Rear axle bush for wheel bearing housing

to fit
Mercedes-Benz C Class (202, 203 and 204),
E Class (207, 211 and 212), S Class (221) and
other models

SWAG No. 10 92 1174
Repl. no. 204 352 00 27

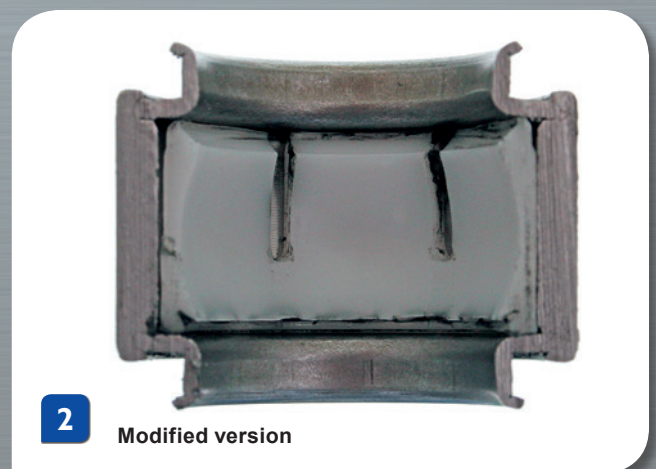
Knocking or creaking noises can occur in the region of the rear axle when driving.

Due to its design, the rear axle bush is shortened by poor road and weather conditions. The version originally fitted (Repl. no. 201 352 00 27) has a lubrication channel in the inner plastic tray (see Fig. 1). However, this is not always sufficient to lubricate the joint evenly. The drying out that is sometimes associated with this makes the joint susceptible to wear. Mercedes-Benz has withdrawn this version from service and replaced it.

SWAG recommends using the new version of the joint SWAG 10 92 1174 (Repl. no. 204 352 00 27). The modified joint has several channels instead of just one (see Fig. 2). This ensures a permanent supply of grease which lengthens the joint's lifetime.
